XK 140 MODEL

ELECTRICAL AND INSTRUMENTS

WINDSCREEN WIPER MOTOR - REPLACING TYPE DR1 WITH TYPE DR3

DR3 MOTOR and PRS7 SWITCH

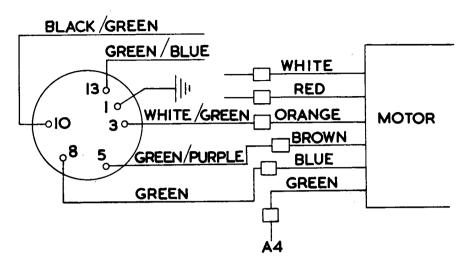
The DR3 wiper motor and the DR1 motor are similar type units, both being two speed, self-parking wipers, the main difference between the two units being that whereas with the DR1 the mounting pillars are secured to the motor portion, the pillars are cast as part of the gearbox with DR3 units. Therefore a conversion bracket Jaguar Part No. 7259 (Lucas Part No. 744144) will be necessary with each DR3 replacement which when bolted to the DR3 mounting pillars, will allow the new unit to be fitted as a direct replacement for the DR1 motor.

- Cut off the original five connectors from the wiper motor harness, and solder on the five "bullet" connectors.
- 2) Using rubber snap connectors, connect the leads from the DR3 motor to the harness, as illustrated below.

It will be necessary to remove and tape up the green cable feeding the panel control switch, since it is no longer required. With PRS7 switches, the feed cables is connected to terminal 8. Using the length of green cable supplied with the replacement motor, connect the green lead from the motor to the "A4" fuse box terminal.

- 1) Disconnect the cable and remove the original motor from the vehicle. To disconnect the cross-head and flexible rack, the circlip (or hexagon nut on earlier DRI motors) around the gear shaft on the underside of the gearbox should be removed. This will allow the final gear assembly to be partially withdrawn so that the connecting rod can be lifted clear of the cross head.
- 2) Remove the gearbox cover and circlip from the replacement DR3. Partially withdraw the final gear assembly and connecting rod, and attach the crosshead to the connecting rod. Push the final gear back into its original position and replace the circlip and gearbox cover.
- 3) Fit the conversion bracket to the motor, and bolt the assembly in position on the vehicle.

If on testing the wiper it is found that the blades fail to park correctly, the parking position can be corrected by turning the knurled adjusting nut located near the gearbox cable outlet, one or two serrations at a time until the correct position is obtained.
